PERMIT REPORT

Re: Metropolitan Council; Permit 18-670: Emergency Relief Structure 04 and Sanitary Tunnel 344 – Minnehaha Parkway, Minneapolis

2
GC16
BRIDGE SECTION LOOKING SOUTH
NO SCALE

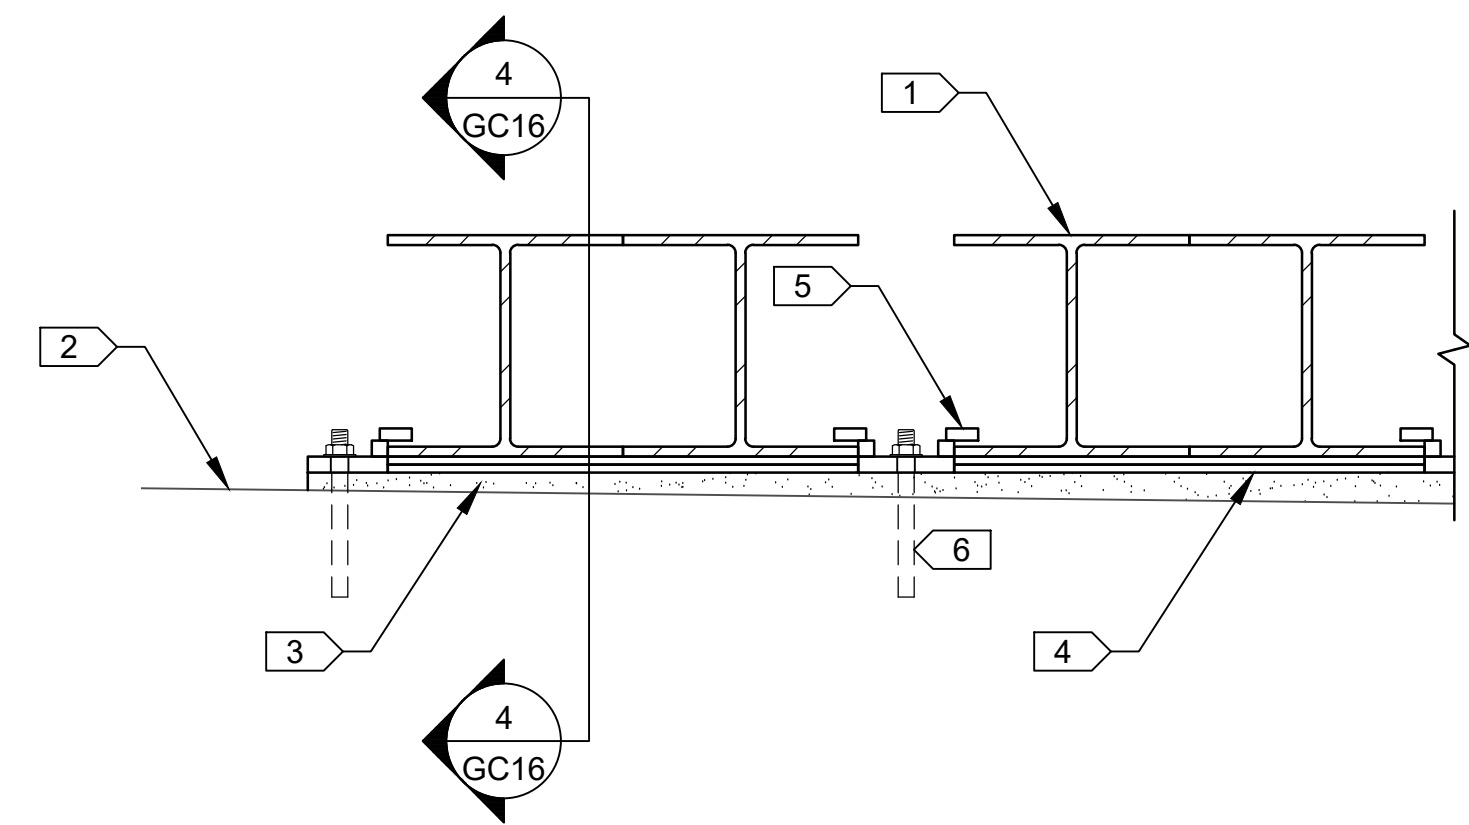
Section 3(b) of the rule requires no increase in the 100-year flood elevation of a watercourse. The bridge abutments make up 0.5% of the cross-sectional area of the channel and the temporary conveyance under the Minnehaha Parkway bridge make up 0.2% of the cross sectional area of the channel. The modification is smaller than the sensitivity of hydraulic models, therefore the applicant has determined that no impact will be made on hydraulic capacity. The District

modification is smaller than the sensitivity of hydraulic models, therefore the applicant has determined that no impact will be made on hydraulic capacity. The District Engineer concurs with the analysis and that hydraulic capacity is maintained.
